# UNITED STATES PATENT AND TRADEMARK OFFICE

APPLICATION NO.	FILING DATE	FIRST NAMED INVENTOR	ATTORNEY DOCKET NO.	CONFIRMATION NO.
10/540,969	06/29/2005	Stephen Pasquarella	89200.000007	4313
23387	7590	12/17/2008		
Stephen B. Salai, Esq. Harter Secrest & Emery LLP 1600 Bausch & Lomb Place Rochester, NY 14604-2711			EXAMINER KOVAL, MELISSA J	
			ART UNIT 2862	PAPER NUMBER
			MAIL DATE 12/17/2008	DELIVERY MODE PAPER

# Office Action Summary

**DETAILED ACTION**

See Figures 2 and 3, for example.

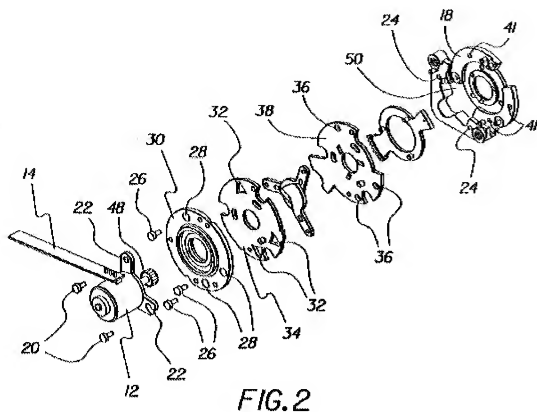
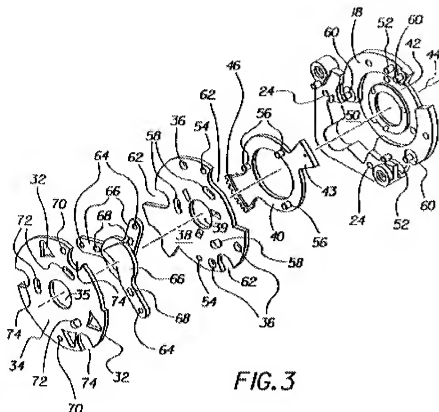
4. Claims 15 and 16 are rejected under 35 U.S.C. 102(b) as being anticipated by Bovenzi et al. U.S. Patent 5,502,524.

5. Claim 15 sets forth: "A rotary photographic shutter (**See aperture or shutter mechanism 10 shown in Figure 1.**) or the like including a plurality of shutter blades (**shutter blades 66**) movable between an open and a closed position (**Closed positions are shown in Figure 4, and various open positions are shown in Figures 5 and 6.**) a drive means (**stepper motor 12**) including an actuator (**actuator 40**) for moving the shutter blades between the open and closed positions and a damping system operable to arrest the movement of the drive means at one of the open and: closed positions (**First damping member 34 and second damping member 38.**)."
